Project	IEEE 802.16 Broadband Wireless Access Working Group < http://ieee802.org/16 >	
Title	DL and UL loading parameters information	
Date Submitted	2007-03-08	
Source(s)	Peretz Feder – Alcatel-Lucent Phillip Barber - Huawei Honghai Zhang – Alcatel-Lucent	pfeder@alcatel-lucent.com pbarber@broadbandmobiletech.com hozhang@alcatel-lucent.com
Re:	IEEE 802.16 Session #48 – Phone CBR session	
Abstract	This contribution proposes the updates of IEEE 802.16g D8 document in order to obtain loading information from the Base Station	
Purpose	Update 802.16g draft obtain uplink and downlink loading information	
Notice	This document has been prepared to assist IEEE 802.16. It is offered as a basis for discussion and is not binding on the contributing individual(s) or organization(s). The material in this document is subject to change in form and content after further study. The contributor(s) reserve(s) the right to add, amend or withdraw material contained herein.

DL and UL loading parameters information

2. Proposed Text Change

Figure 57 – Maintaining downlink synchronization

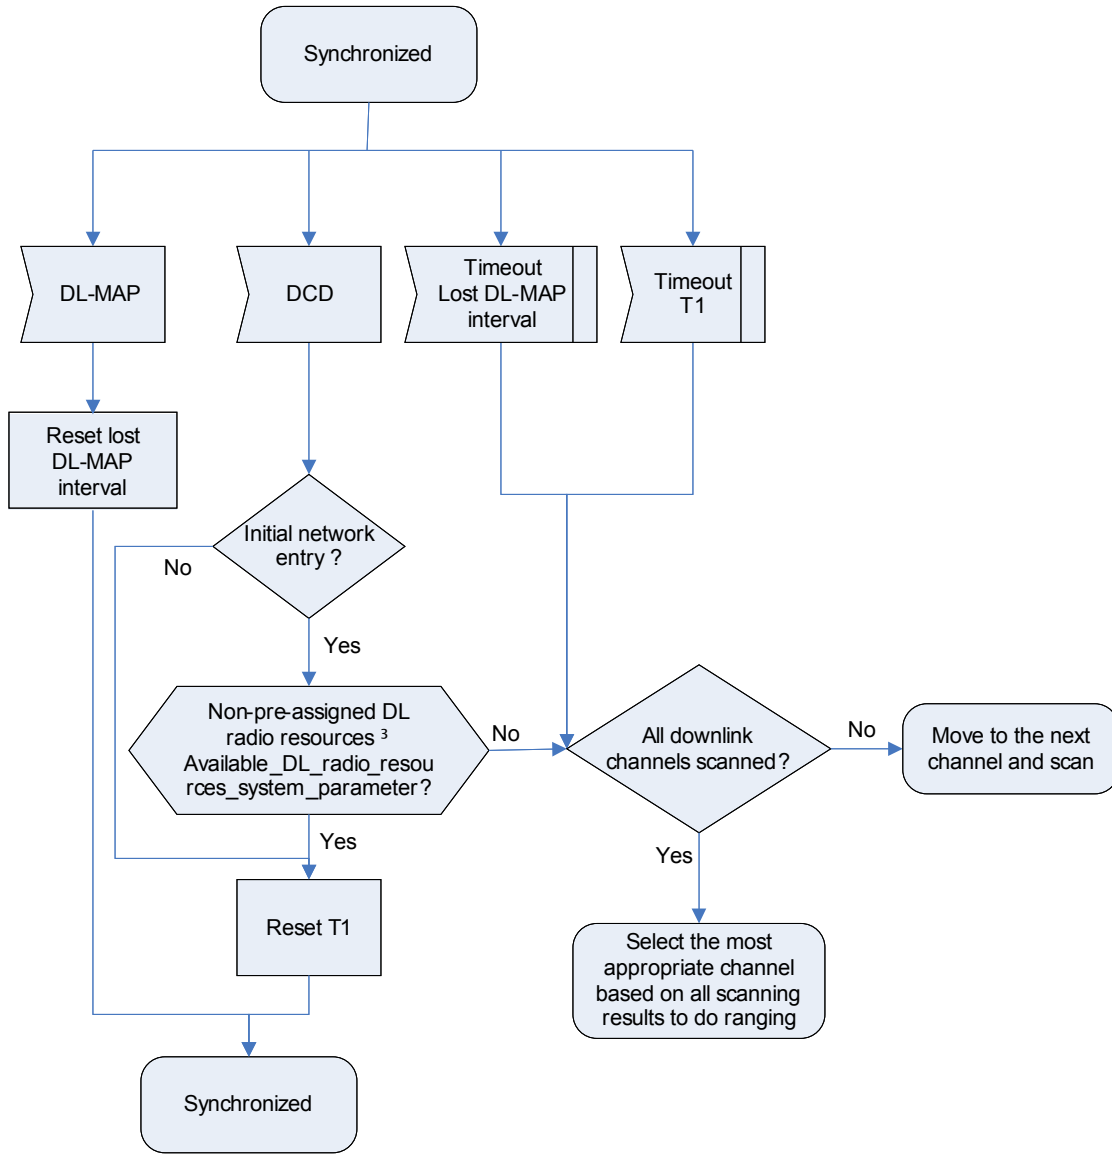
(Note to Editor: Need to modify Figure 57 – see below)

The MAC shall search for the DL-MAP MAC management messages. The SS achieves MAC synchronization once it has received at least one DL-MAP message and is able to decode the DL-Burst Profiles contained therein. An SS MAC remains in synchronization as long as it continues to successfully receive the DL-MAP and DCD messages for its channel **upon network entry only** and the Non-pre-assigned DL radio resources in the DCD message are higher than or equal to the available_DL_radio_resources_system_parameter. If the reported Non-pre-assigned DL radio resources are less than the available_DL_radio_resources_system_parameter, the SS/MS should continue scanning to find another channel until all channels are scanned. If all channels are scanned, the MS should choose the most appropriate channel to perform initial ranging according to section 6.3.9.5 based on conditions that include **RSSI**, CINR and the available Non-pre-assigned DL/UL radio resources of all channels. If the Lost DL-MAP Interval (Table 342) has elapsed without a valid DL-MAP message or the T1 interval (Table 342) has elapsed without a valid DCD message, an SS shall try to reestablish synchronization. The process of acquiring synchronization is illustrated in Figure 56. The process of maintaining synchronization is illustrated in Figure 57. (language change: add MS and SS section to explain better – perform MAC HO function 6.3.25 or 22?. SS initial entry)

Figure 58 – Obtaining uplink parameters

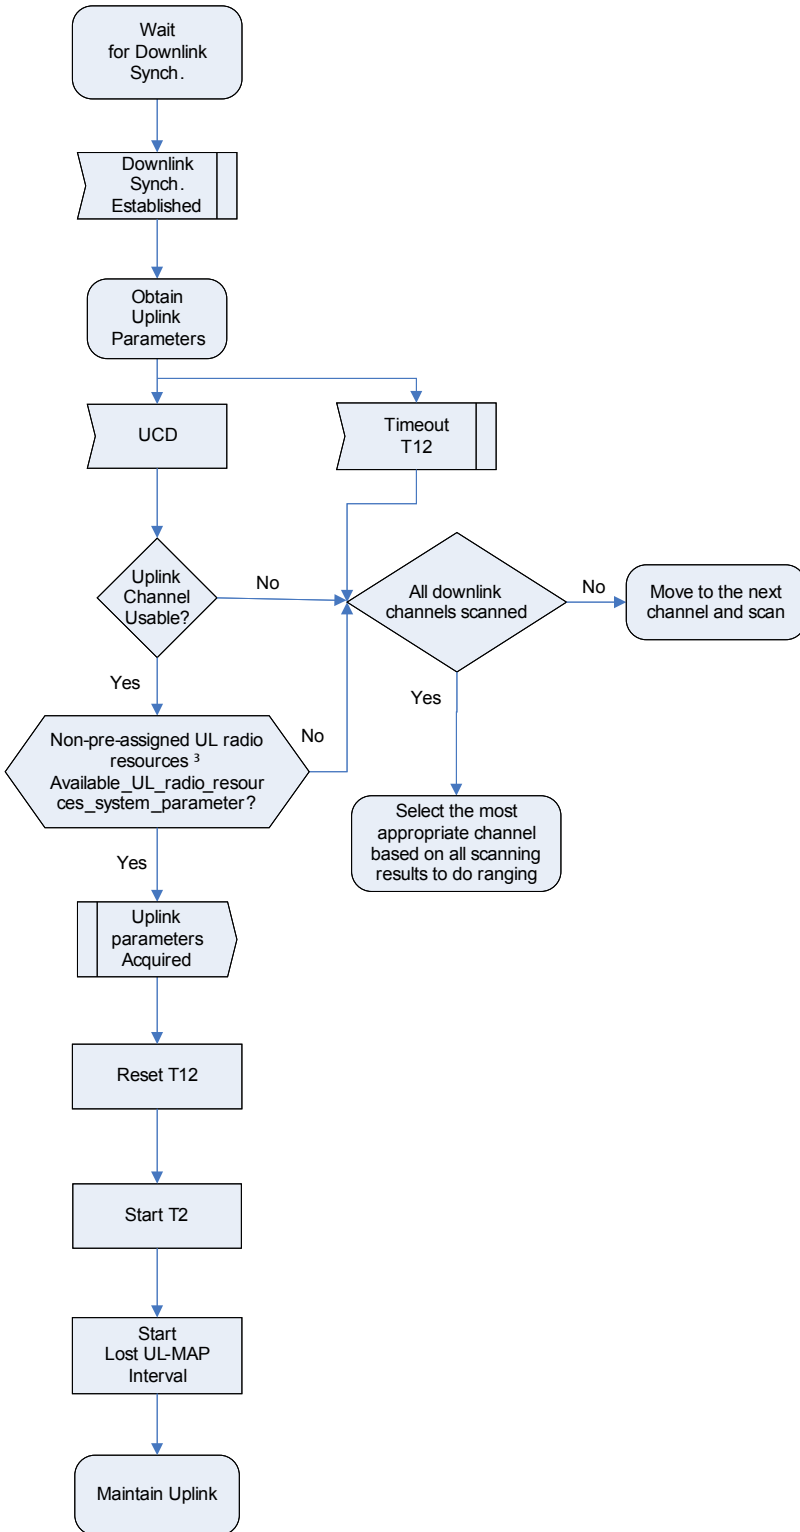
If no uplink can be found after a suitable timeout period, **or if the Non-pre-assigned UL radio resources in the UCD message are lower than the available_UL_radio_resources_system_parameter**, then the SS shall continue scanning to find another downlink channel. The process of obtaining uplink parameters is illustrated in Figure 58. (Editor: need to change Figure 58 – see below)

Figure 59 – Maintain uplink parameters

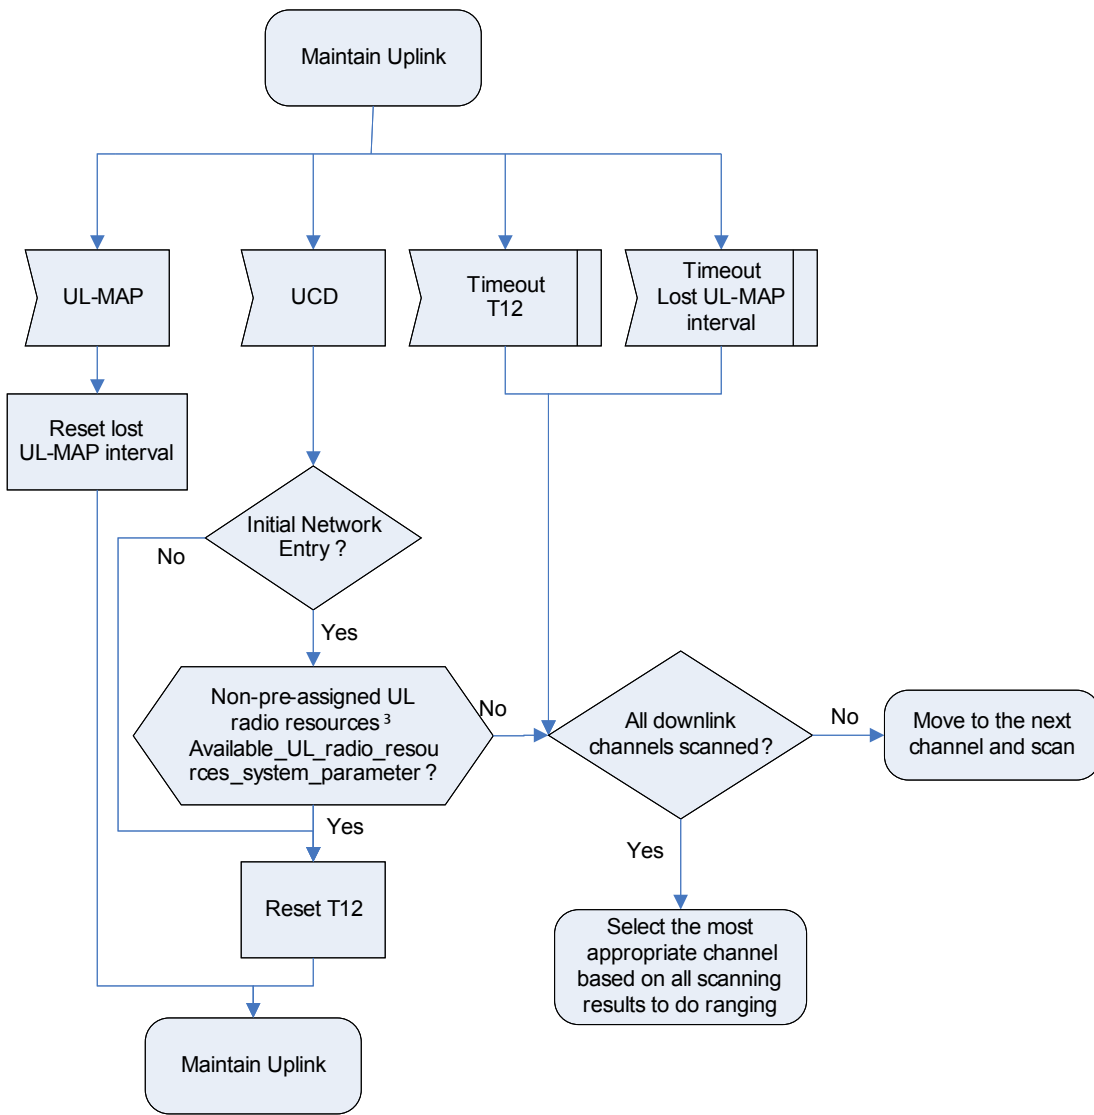
The SS MAC is considered to have valid uplink parameters as long as it continues to successfully receive the UL-MAP and UCD messages. If at least one of the messages is not received within the time intervals specified in Table 342 or the Non-pre-assigned UL radio resources are lower than the `available_UL_radio_resources_system_parameter`, the SS shall not use the uplink. This is illustrated in Figure 59.

(Editor: need to change Figure 59 – see below)
